PLANNING AND ZONING COMMISSION AGENDA

MONDAY, SEPTEMBER 14, 2015

**STAFF REPORT
KETCHUM PLANNING AND ZONING COMMISSION
REGULAR MEETING OF SEPTEMBER 14, 2015**

PROJECT: Rivelo Waterways Design Review

A PRELIMINARY HOUSE LAYOUT ON
LOT 3, BLK 1, CREEKBEND SUBDIVISION
 WITHIN S13, T.4N., R.18E., B.M., CITY OF KETCHUM, BLAINE COUNTY, IDAHO
 PREPARED FOR THE RIVEROS AND THE JARVIS GROUP

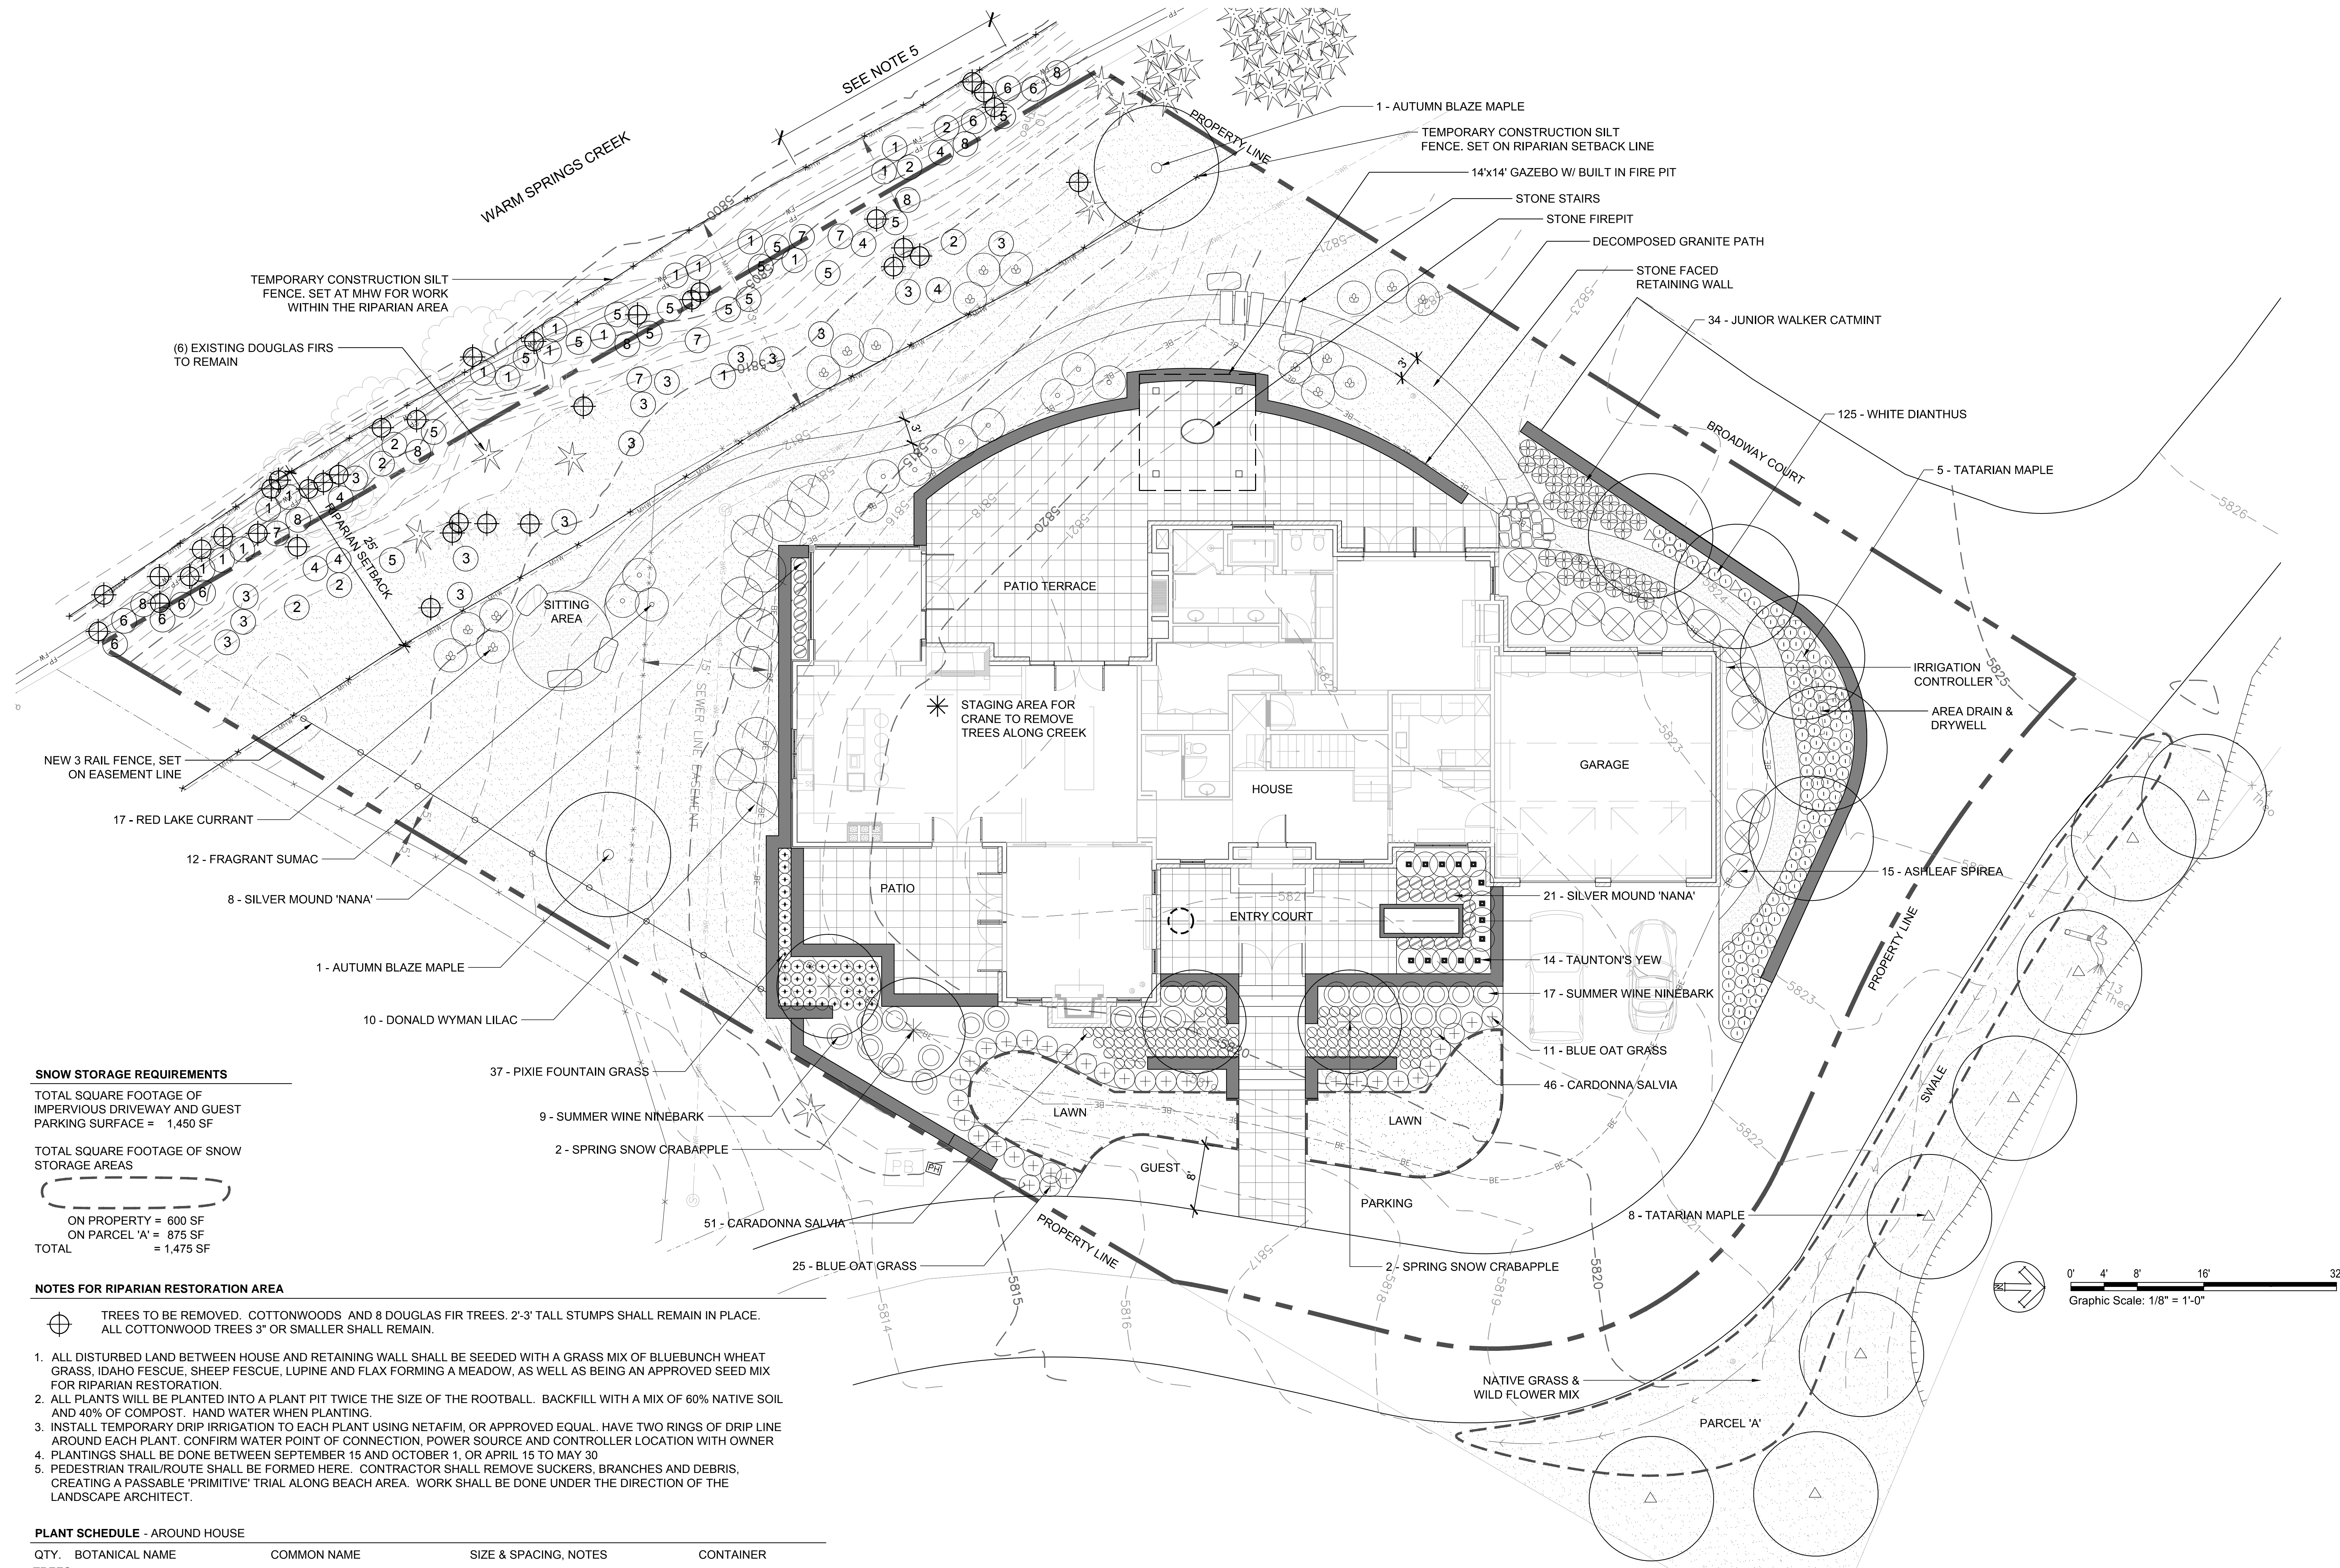
Staff Comments	<i>The subject property does not contain floodplain. The house and terraces are set back a minimum of thirteen (13) feet from the riparian setback line and that area will be vegetated with a native grass/wildflower mix.</i>
<input checked="" type="checkbox"/>	<input type="checkbox"/>	<input type="checkbox"/>	17.88.060(E)7	Impacts of the development on aquatic life, recreation, or water quality upstream, downstream or across the stream are not adverse.
			Staff Comments	<i>No development is proposed in or near the river, and the riparian setback has been respected. There will be no adverse impact from the development on aquatic life, recreation or water quality.</i>
<input checked="" type="checkbox"/>	<input type="checkbox"/>	<input type="checkbox"/>	17.88.060(E)8	Building setback in excess of minimum required along waterways is encouraged.
			Staff Comments	<i>The house and terraces are set back a minimum of thirteen (13) feet in excess of the minimum twenty-five (25) foot riparian setback.</i>

4. At time of building permit submittal, stamped structural engineered drawings, prepared by a registered design professional, licensed in the State of Idaho, shall be submitted for the foundation;

ARCHITECTURAL CONCRETE WALL FOR DESIGN REVIEW APPROVAL

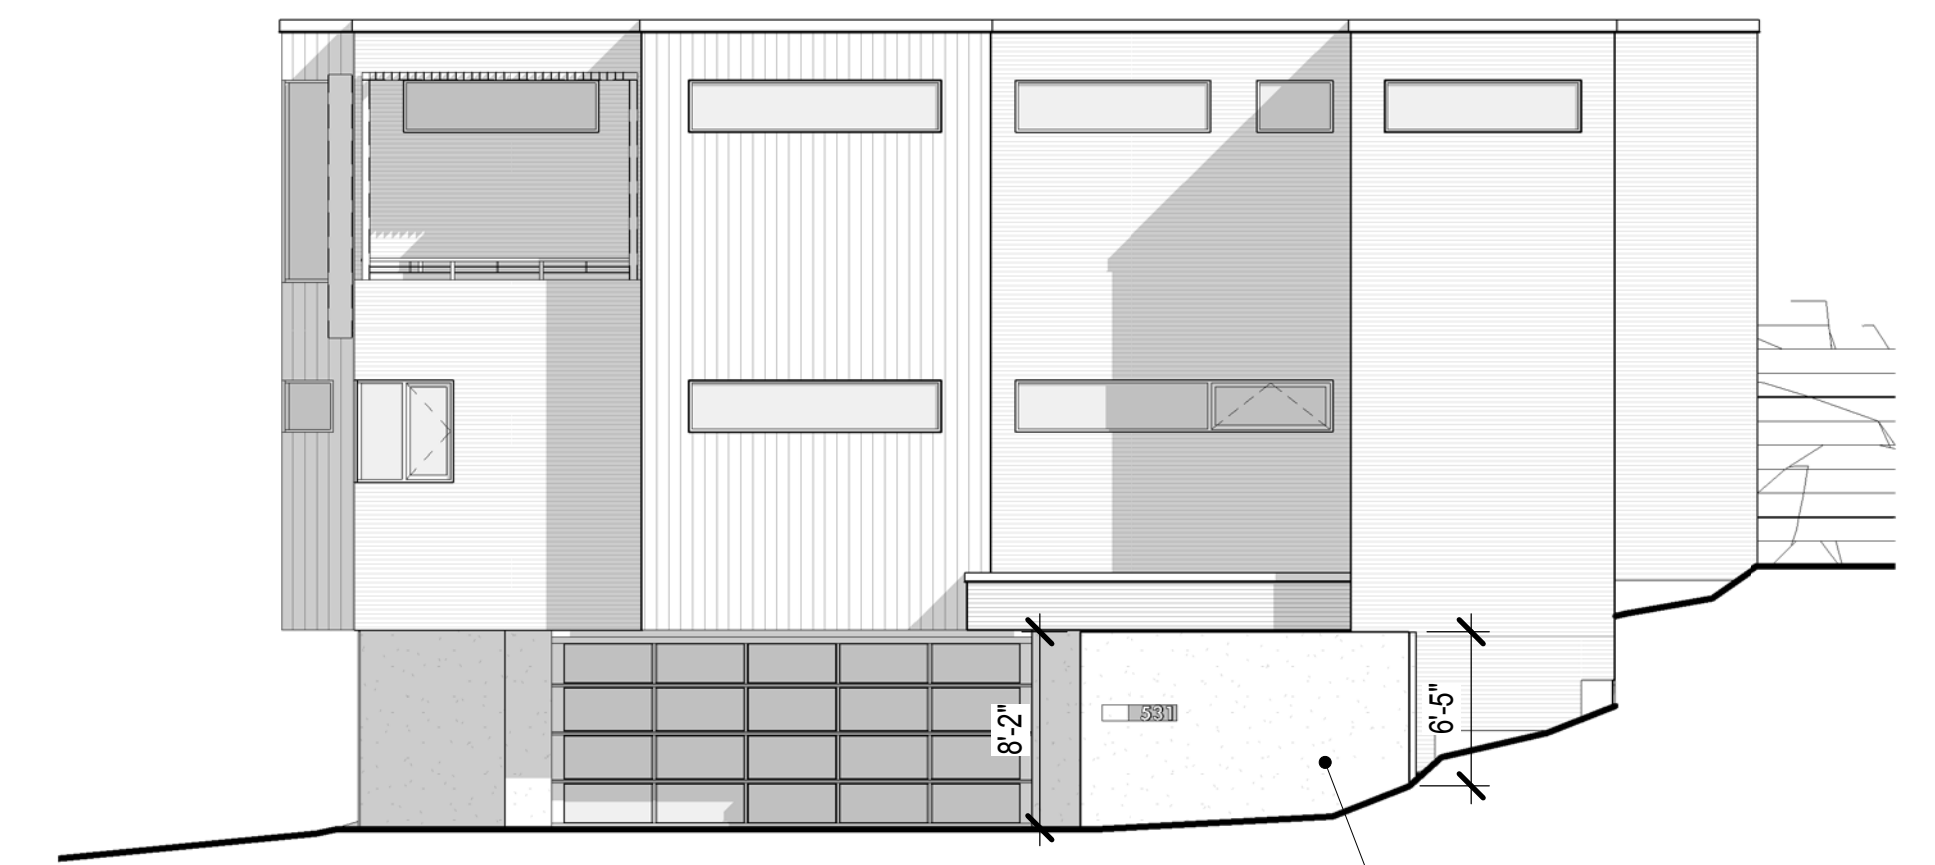
The applicant is proposing the addition of a site wall containing a height of 8'-2". The proposed wall is 14 feet in length and constructed with architectural concrete. The applicant indicates that the wall will serve to enhance privacy for the entry court of the new home. An application for the proposed wall was submitted with the building permit (#14-090) prior to the adoption of the new zoning ordinance Title 17 (Ordinance 1135). The zoning ordinance at the time the building permit was submitted contained a provision, now eliminated, that granted the Planning and Zoning Commission authority to approve additional fence and wall height through

<i>Staff Comments</i>	<i>The proposed wall is designed with a similar architectural design and color as the residence.</i>
<input checked="" type="checkbox"/>	<input type="checkbox"/>	<input type="checkbox"/>	17.96.090(B)(3)e	Building walls which are exposed to the street shall be in scale with the pedestrian.
			<i>Staff Comments</i>	<i>The proposed wall is setback back from the street and does not appear to be out of scale to the pedestrian.</i>
<input checked="" type="checkbox"/>	<input type="checkbox"/>	<input type="checkbox"/>	17.96.090(B)(3)f	Building walls shall provide undulation/relief thus reducing the appearance of bulk and flatness.
			<i>Staff Comments</i>	<i>The elevation views provided suggest that the proposed wall is flat and does not contain variation. The Commission may consider requiring additional variation. However, the subject wall is only 14 feet in length.</i>

1. Design Review approval shall expire one (1) year from the date of approval;
2. Design Review elements shall be completed prior to final inspection/occupancy, and
3. This Design Review approval is based on the plans and information presented and approved at the meeting on the date noted herein. Building Permit plans must conform to the approved Design Review plans unless otherwise approved in writing by the Planning and Zoning Commission or Administrator. Any building or site discrepancies which do not conform to the approved plans will be subject to removal.
